THISLEWAITE PLACE SUBDIVISION

APPLICATION NUMBER 7 DATE October 1, 2009

APPLICANT Thistlewaite Place Subdivision

REQUEST Subdivision

DETAIL SITE PLAN

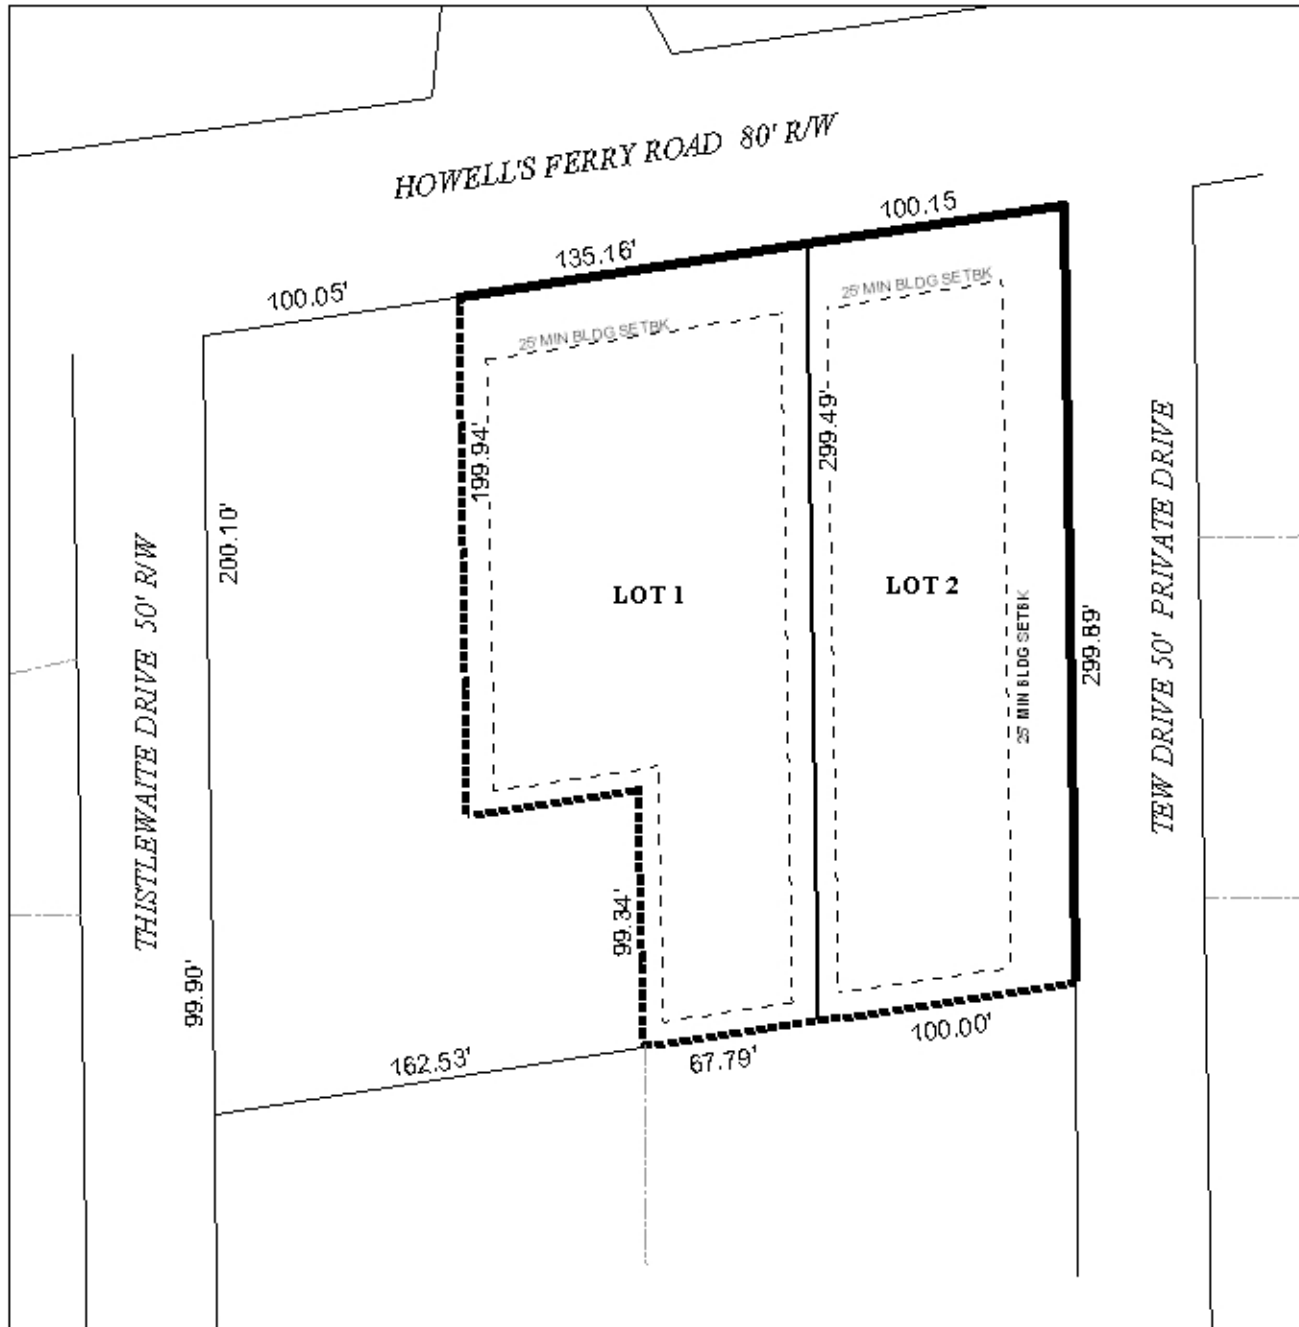
As proposed, Lots 1 and 2 have approximately 135' and 100' of frontage, respectively, along Howells Ferry Road, while Lot 2 has approximately 300' of frontage along Tew Drive. As a means of access management, a note should be placed on the final plat stating that each lot is limited to one curb cut each (including the corner lot), with the size, location, and design to be approved by Traffic Engineering and in conformance with AASHTO standards. It should be noted, however, if access is to be provided from Tew Drive, then compliance with Section VIII.E of the Subdivision Regulations will be required.

As proposed, the plat does not illustrate adequate radii where Howells Ferry Road intersects Tew Drive. The applicant should revise the plat to comply with Section V.B.16 of the Subdivision Regulations.

- 1) placement of a note on the final plat stating that each lot is limited to one curb cut each (including the corner lot), with the size, location, and design to be approved by Traffic Engineering and in conformance with AASHTO standards;
- 2) placement of a note on the final plat stating that access to Tew Drive will require compliance with Section VIII.E of the Subdivision Regulations;
- 3) provision of an adequate radius, in compliance with Section V.B.16 of the Subdivision Regulations, at the intersection of Howells Ferry Road and Tew Drive;
- 4) placement of a note on the plat / site plan stating that the site must be developed in compliance with all local, state and Federal regulations regarding endangered, threatened or otherwise protected species.
